APPENDIX L

Utility Provider Service Letters

THE BROOKSIDE TENTATIVE TRACT NO. 72798

Comment Letter for Tentative Tract Map No. 72798

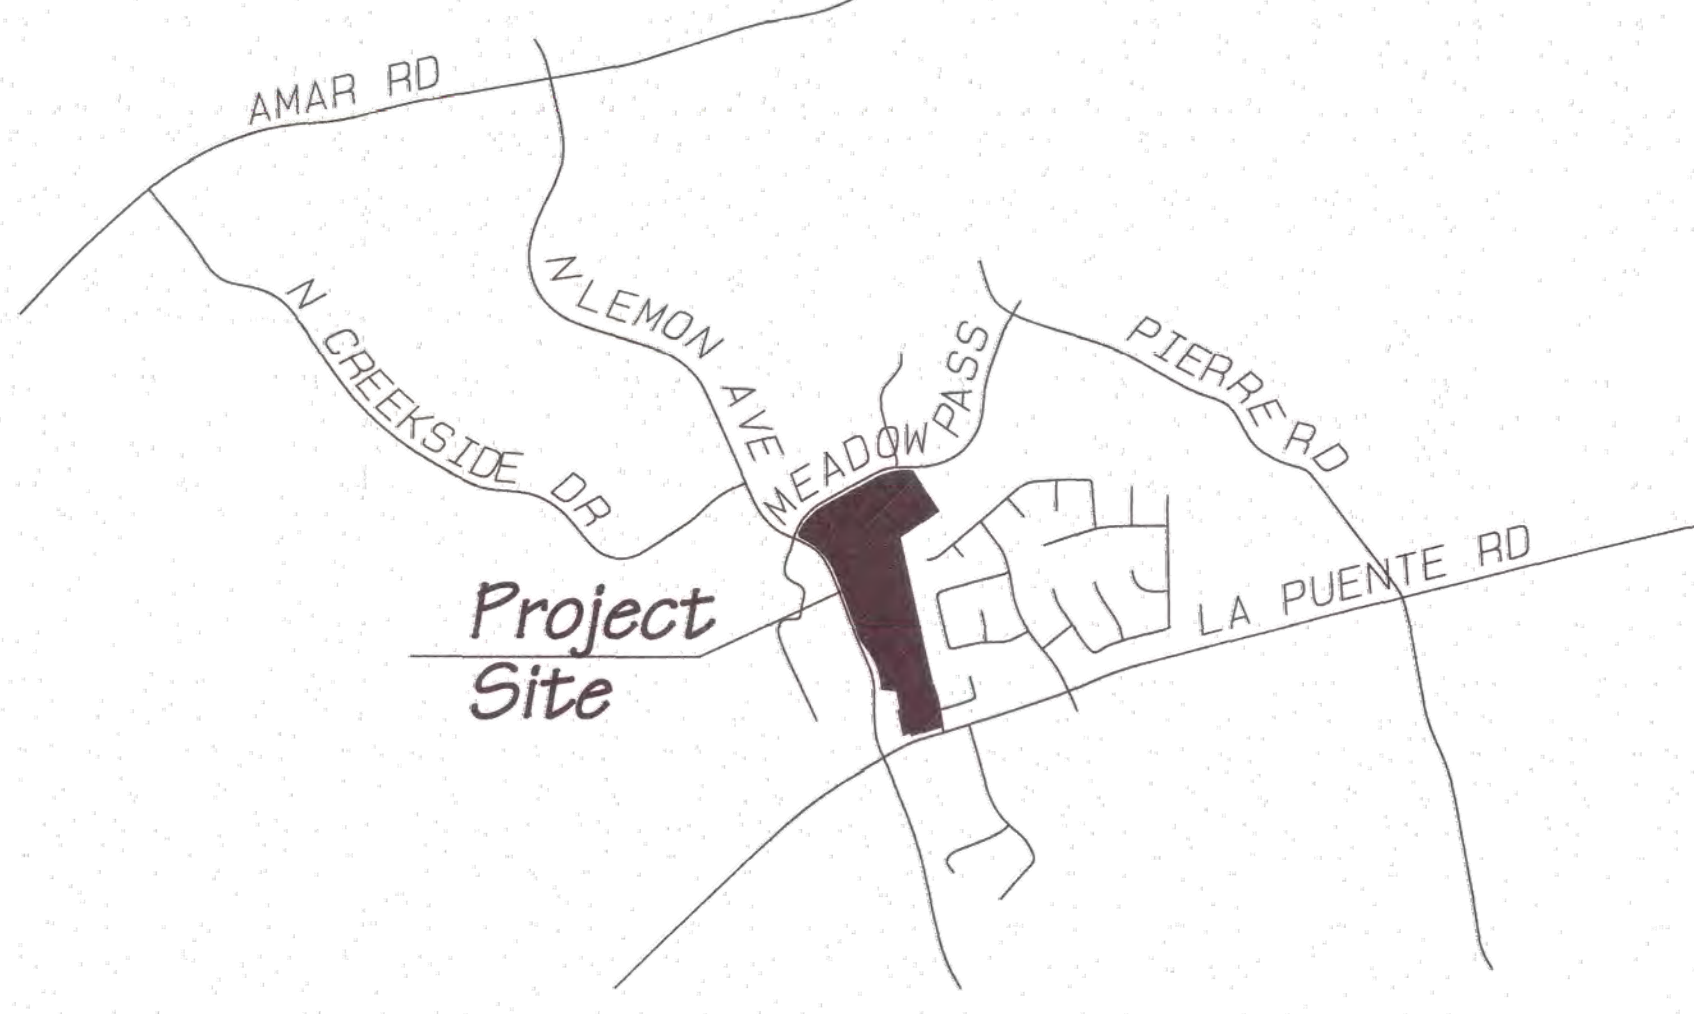
Enclosed with this questionnaire is a redlined map of the District existing facilities within the vicinity of the project site.

**THE BROOKSIDE
TENTATIVE TRACT NO. 72798**
City of Walnut, County of Los Angeles

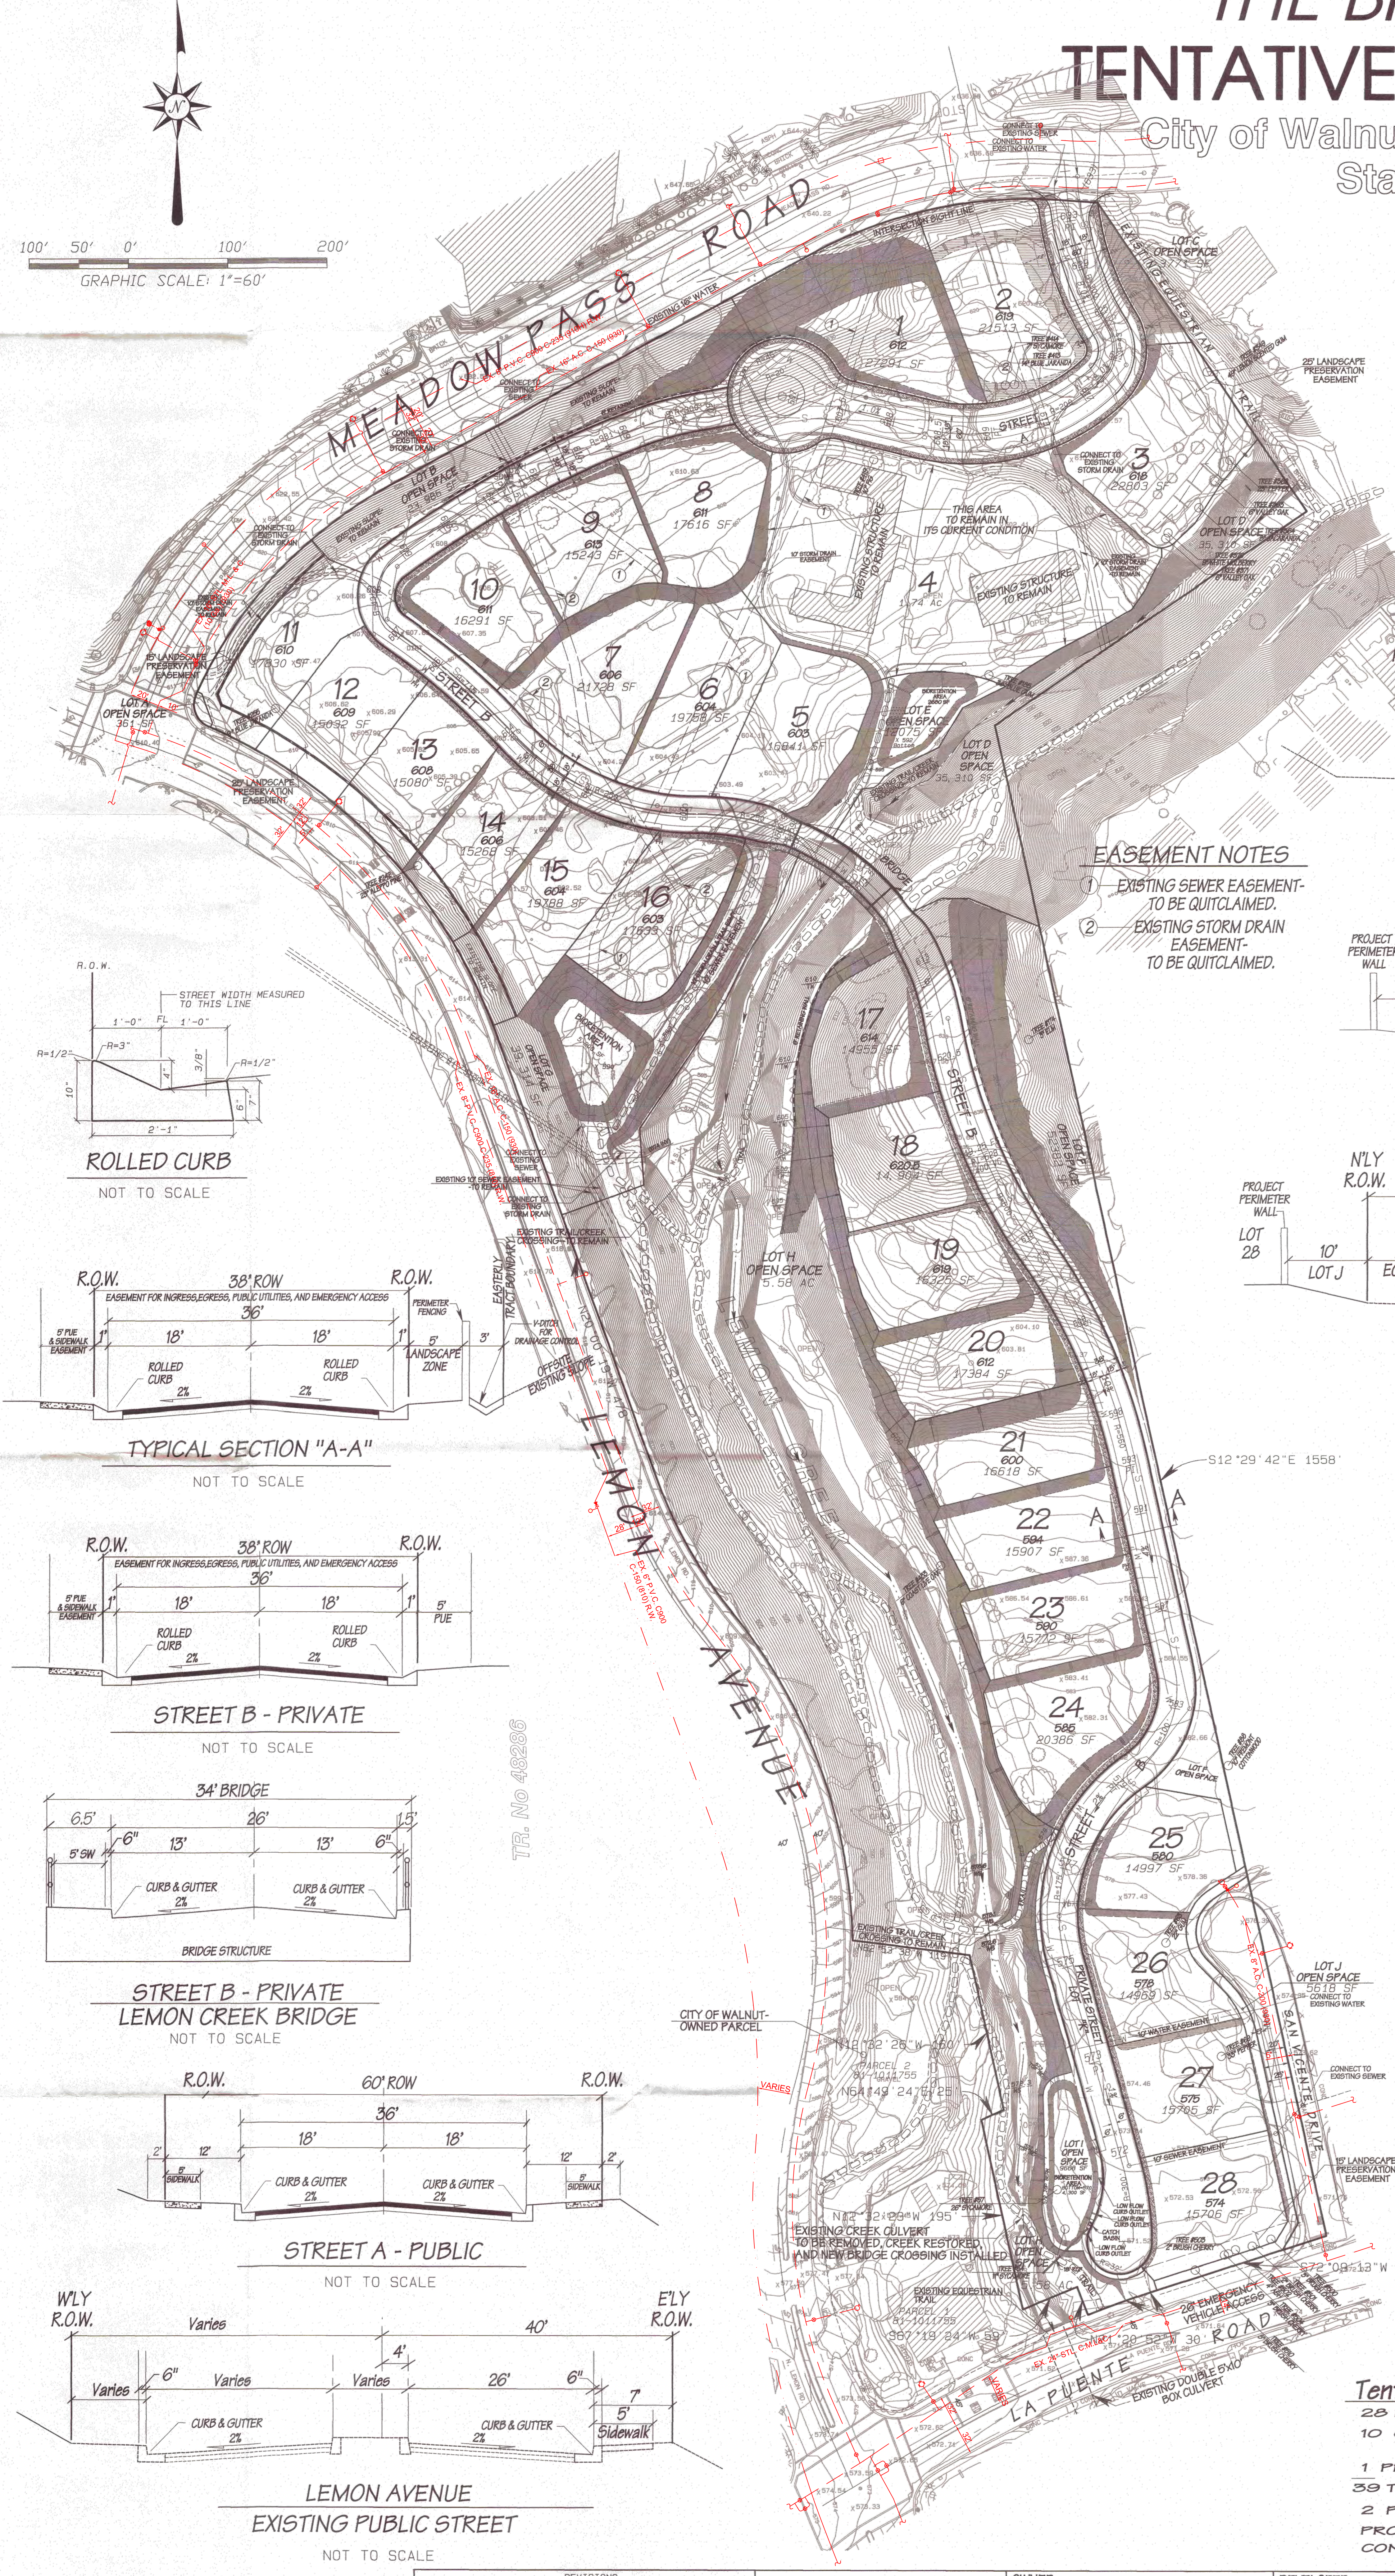
The Sanitation Districts of Los Angeles County (Districts) received the letter and plans for the subject project forwarded by your office on June 18, 2018. The proposed project is located within the jurisdictional boundaries of District No. 21. We offer the following comments regarding sewerage service:

1. The wastewater flow originating from the proposed project will discharge to a local sewer line, which is not maintained by the Districts, for conveyance to the Districts' Lemon Avenue Trunk Sewer, located in Lemon Avenue at Valley Boulevard. The Districts' 18-inch diameter trunk sewer has a capacity of 7.8 million gallons per day (mgd) and conveyed a peak flow of 0.7 mgd when last measured in 2014.

2. The wastewater generated by the proposed project will be treated at the San Jose Creek Water Reclamation Plant (WRP) located adjacent to the City of Industry, which has a capacity of 100 mgd and currently processes an average flow of 64.7 mgd. All biosolids and wastewater flows that exceed the capacity of the San Jose Creek WRP are diverted to and treated at the Joint Water Pollution Control Plant in the City of Carson.

3. The expected average wastewater flow from the project, described in the map as 28 residential lots, is 7,280 gallons per day, based on the estimated flow from 28 single family homes. For a copy of the Districts' average wastewater generation factors, go to www.lacsd.org, Wastewater & Sewer Systems, click on Will Serve Program, and click on the [Table 1, Loadings for Each Class of Land Use](#) link.
